STAFF RECOMMENDATION 1511 16th Avenue South January 20, 2021

Application: New Construction—Infill
District: South Music Row Neighborhood Conservation Zoning Overlay
Council District: 19
Base Zoning: OR20
Map and Parcel Number: 10408042800
Applicant: Manuel Zeitlin
Project Lead: Melissa Sajid, melissa.sajid@nashville.gov

<p>Description of Project: The request is to construct infill on a vacant lot.</p> <p>Recommendation Summary: Staff recommends of approval of the project with the following conditions:</p> <ol style="list-style-type: none">1. The finished floor height shall be consistent with the finished floor heights of the adjacent historic houses, to be verified by MHZC staff in the field;2. The ridge height will not exceed the height of the two historic buildings to either side;3. The front setback should be consistent with the buildings to either side, to be verified by MHZC staff in the field;4. Revised elevations shall be submitted showing a change in material at the foundation;5. Staff shall review and approve the final selections for all unknown materials prior to purchase and installation;6. Staff approve the masonry color, dimensions and texture; and7. The HVAC shall b

Figure 2. Streetscape including proposed infill and adjacent historic buildings.

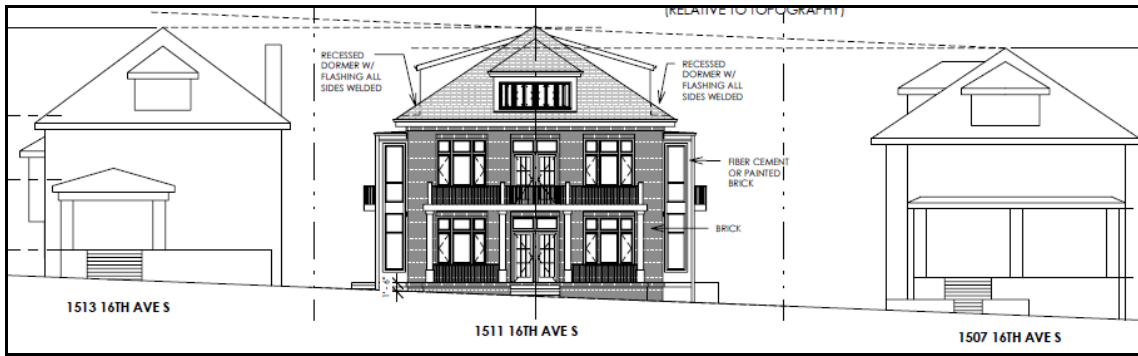
Height, Scale & Building Shape: The new structure is two and a half stories with an overall height of approximately forty-two feet (42') measured from grade to ridge. The historic character of the block has a wide range of building forms including one, one and one-half, two, and two and one-half story forms. The heights of historic buildings range from approximately twenty-two to forty-three feet (22' – 43'), and according to the scaled streetscape on sheet A200 of the plans, the ridge height of the infill shall not exceed ridge height of adjacent historic buildings relative to topography (Figure 2). Staff finds that the proposed two and one-half story form to be appropriate since the site is situated between two historic foursquares.

The primary massing of the infill is forty-one feet (41') wide and the structure widens an additional five feet (5') on both sides approximately sixteen feet, seven inches (16'-7") behind the front wall of the infill.

The subject property is seventy-five feet (75') wide at the street. There are two lots nearby on 16th Avenue South that have a similar width and buildings with a residential form – 1515 and 1615 16th Avenue South. In those cases, building widths are forty feet (40') and forty-eight feet (48'). Staff finds that the proposed building width is compatible with that context and that the primary width of the proposed structure is also compatible with the historic structures on either side of the site. In addition, the design guidelines allow for side additions on wider lots such as this site. Staff finds that the wider side extensions are appropriate given the overall width of the lot, the massing of the new structure in relation to adjacent historic structures, the location of the extension approximately seventeen feet (17') back from the front wall, and the design of the wider extension, which is mainly glazing with a flat roof that sits below the eaves of the primary massing.

The project includes upper-level balconies on the side façades that project an additional two feet (2'). Staff finds that the proposed balconies can be appropriate here since they are located below the eaves and are uncovered.

1. The finished floor height shall be consistent with the finished floor heights of the adjacent historic houses, to be verified by MHZC staff in the field;
2. The ridge height will not exceed the height of the two historic buildings to either side;
3. The front setback should be consistent with the buildings to either side, to be verified by MHZC staff in the field;
4. Revised elevations shall be submitted showing a change in material at the foundation;
5. Staff shall review and approve the final selections for all unknown materials prior to purchase and installation;
6. Staff approve the masonry color, dimensions and texture; and
7. The HVAC shall be located behind the house or on either side beyond the midpoint of the house, and utility meters shall be located on the sides or rear of the building.

① East
1/16" = 1'-0"

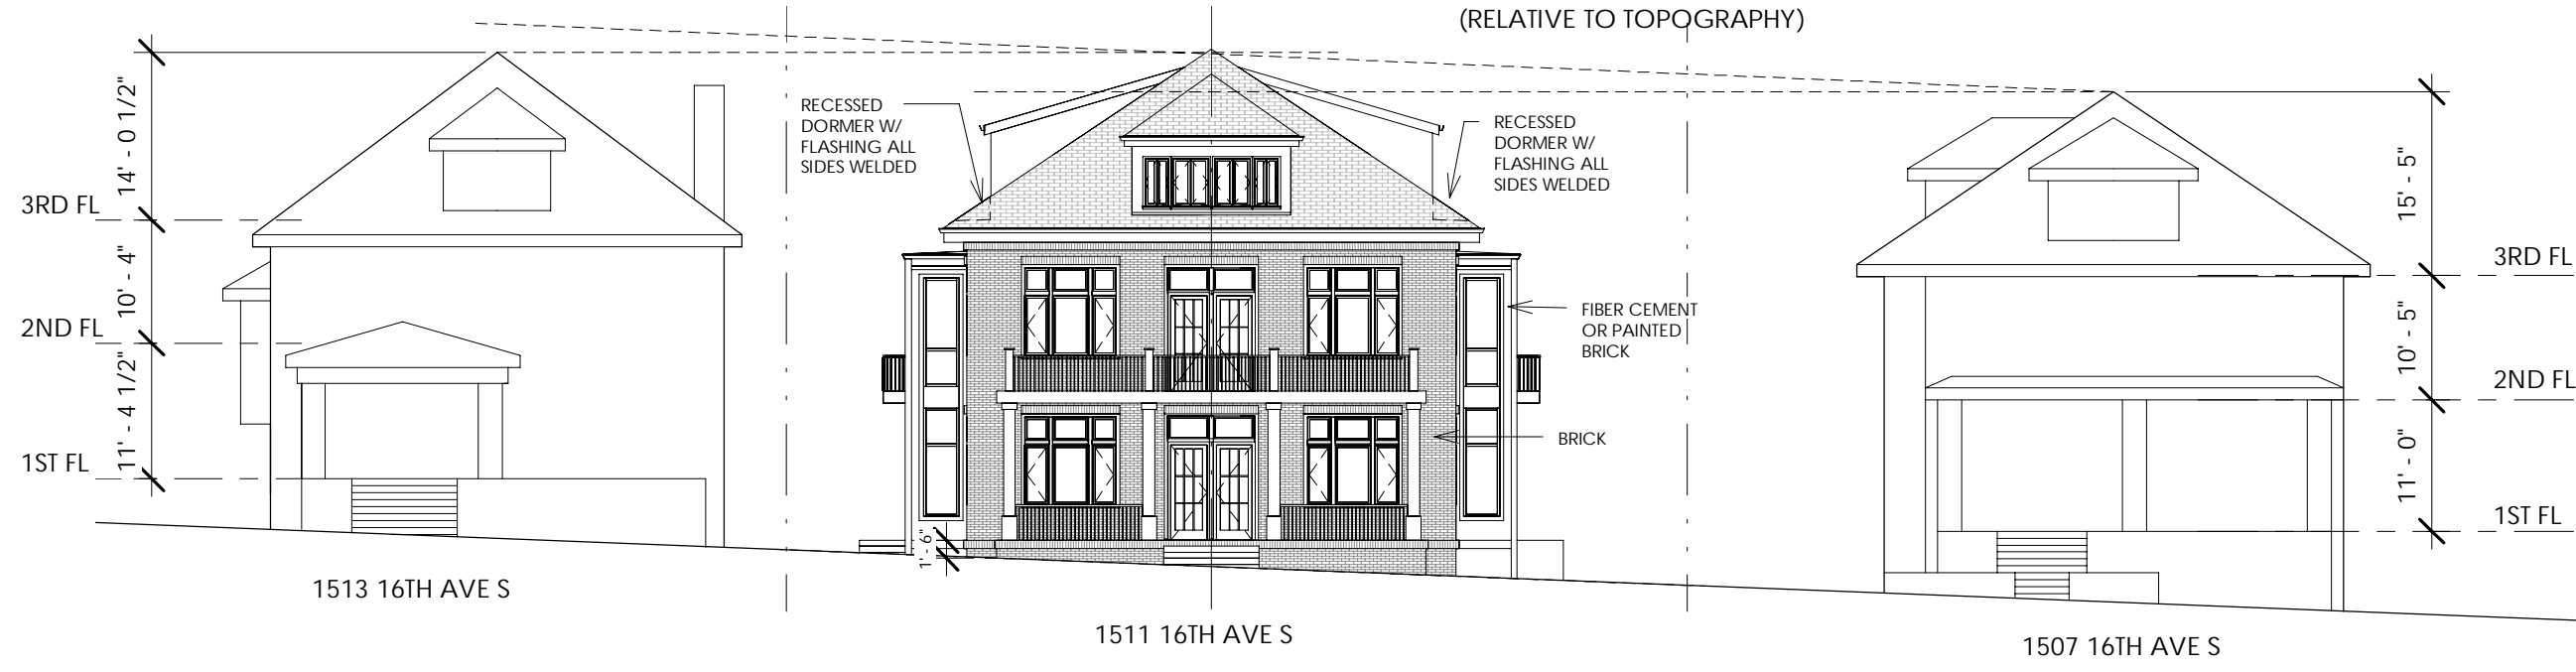
Roof form: The roof is hipped at the front with a front hipped dormer, both with a 9.5/12 pitch. The front dormer sets in two feet (2') from the wall below, which meets the design guidelines. The infill is gabled at the rear with an 8/12 and incorporates shed dormers on the side façades that have a 3.5/12 pitch and are set in two feet (2') from the side walls of the primary massing. The wider two-story bays on both side façades are flat-roofed with a 0.5/12 pitch. The proposed roof forms and pitches are compatible with historic roof forms in the neighborhood. The project meets Section II.B.1.d.

RIDGE OF PROPOSED BUILDING SHALL NOT EXCEED RIDGE HEIGHT OF ADJACENT EXISTING BUILDINGS (RELATIVE TO TOPOGRAPHY)
